Access Compliance Report

Public Rights-of-Way

(Curb Ramps)

Intersection ID: 42461	Main Street: KING_LOUIS_CT	Cross Street: ROYAL_CASTLE_CT	Location: S
ADA ID: E589BE12845D	Ramp Type: PerpDiag	Initial Pass/Fail: Fail	Overall Compliance: No
Severity Score: 8.75			
Codes/Mitigation Info/Possible Solution		Field Measurements/Component Compliance

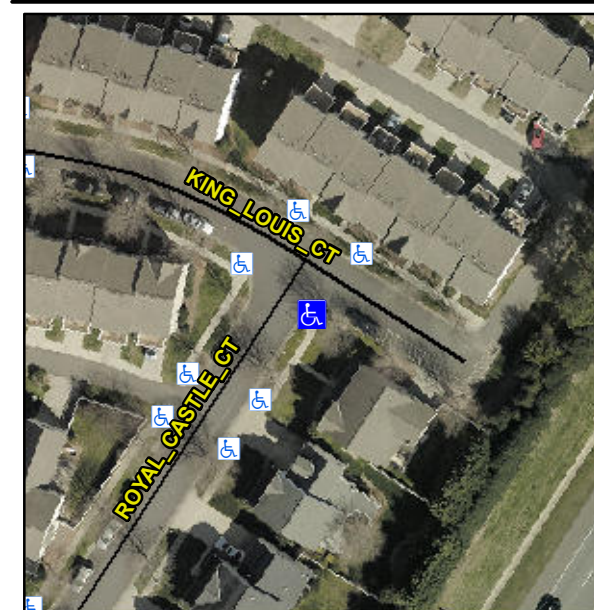
Not Found, R304.5.1

Compliance	Description	Data	Compliance	Description	Data
N/A	Ramp Length (in)	48.0	Yes	Ramp Slope (%)	6.7
No	Ramp Width (in)	38.0	Yes	Ramp XSlope (%)	0.6
N/A	Flare Type LT	N/A	N/A	Flare Type RT	N/A
N/A	Flare Slope LT (%)	N/A	N/A	Flare Slope RT (%)	N/A
N/A	Flare Traversable LT?	N/A	N/A	Flare Traversable RT?	N/A
N/A	Landing Length (in)	N/A	N/A	DWS Provided?	N/A
N/A	Landing Width (in)	N/A	N/A	DWS Contrast?	N/A
N/A	Landing Slope (%)	N/A	N/A	DWS Length (in)	N/A
N/A	Landing X Slope (%)	N/A	N/A	DWS Full Width?	N/A
N/A	Landing Curb? (Y/N)	N/A	N/A	DWS Offset (in)	N/A
N/A	Shared Landing?	N/A			
N/A	Gutter Ponding?	N/A	N/A	Gutter Slope (%)	N/A
N/A	Gutter Lip Ht (in)	N/A	N/A	Gutter X Slope (%)	N/A
N/A	Painted X Walk1?	No	N/A	Painted X Walk2?	No
	X Walk 1 Direction	To NE		X Walk 2 Direction	To NW
N/A	X Walk 1 Width (in)	N/A	N/A	X Walk 2 Width (in)	N/A
	X Walk 1 Slope (%)	1.9		X Walk 2 Slope (%)	2.0
	X Walk 1 X Slope (%)	1.3		X Walk 2 X Slope (%)	2.3

Remove & Replace Curb Ramp With Two New Directional Ramps or Equivalent.
